Sedgwick County
EMS Post 15
3575 N. Webb Road
Wichita, Kansas
RFB#: 18-0023

Addendum No. 2
March 30, 2018
KA # 17045

SPECIFICATIONS AND DRAWINGS

B WALL SECTION
AT SOUTH WALL
1/2"=1'-0"

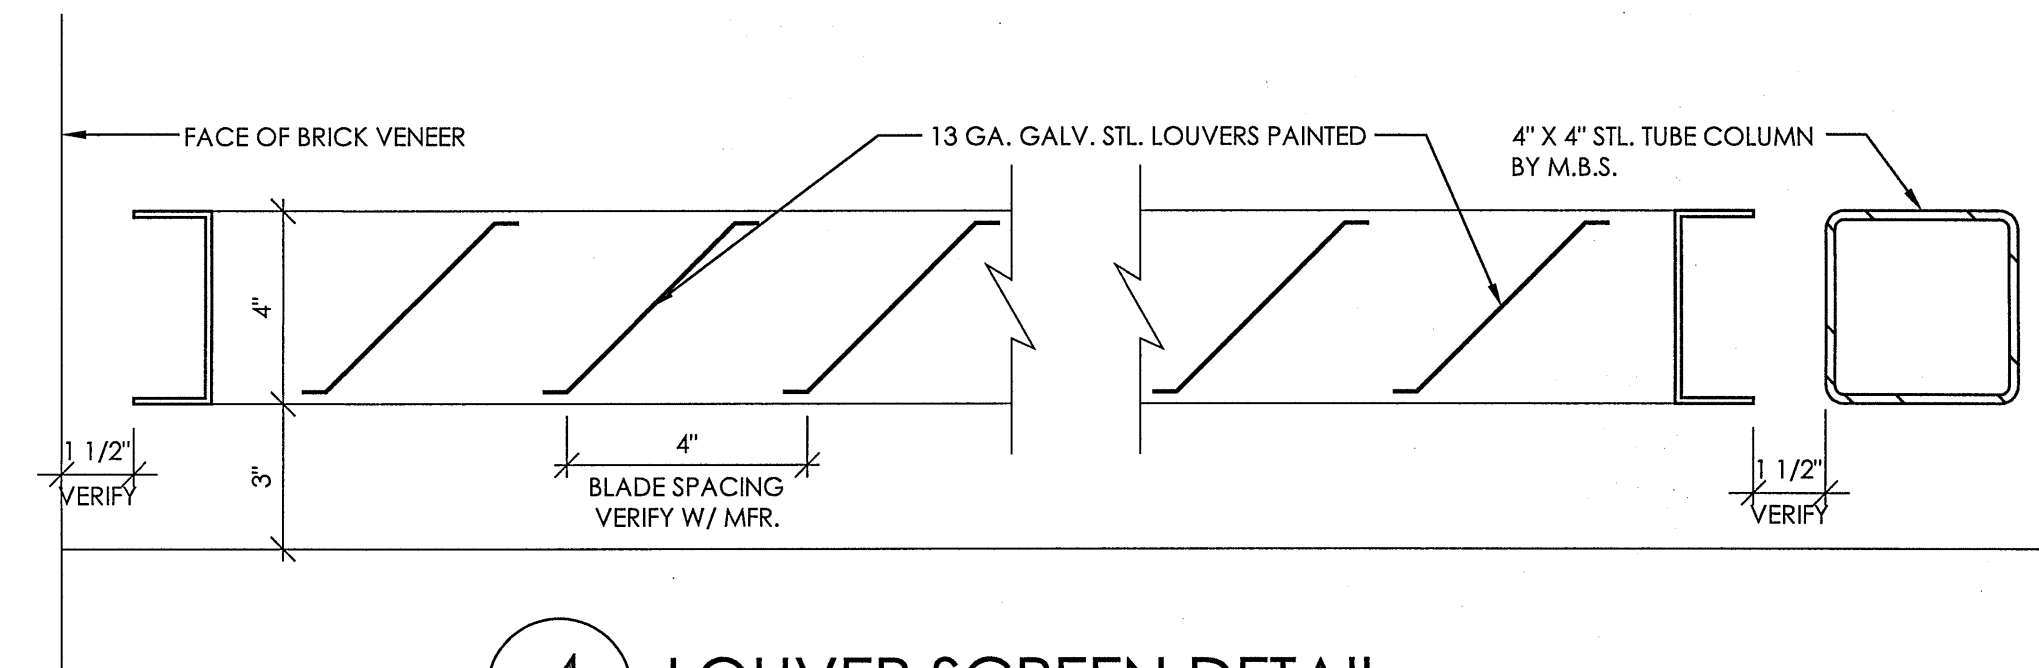
- E. Lintel above building entry door mark 1 and sidelight is to be a 6x4x1/4 steel tube in lieu of the metal stud box header indicated. Lintel to be supported on the north end by a 4x4x1/4 steel tube column and on a steel support angle off of the masonry wall on the south end. Ref. Revised sheets S1.1, A1.1, and details 16/A1.4, B/A3.1.
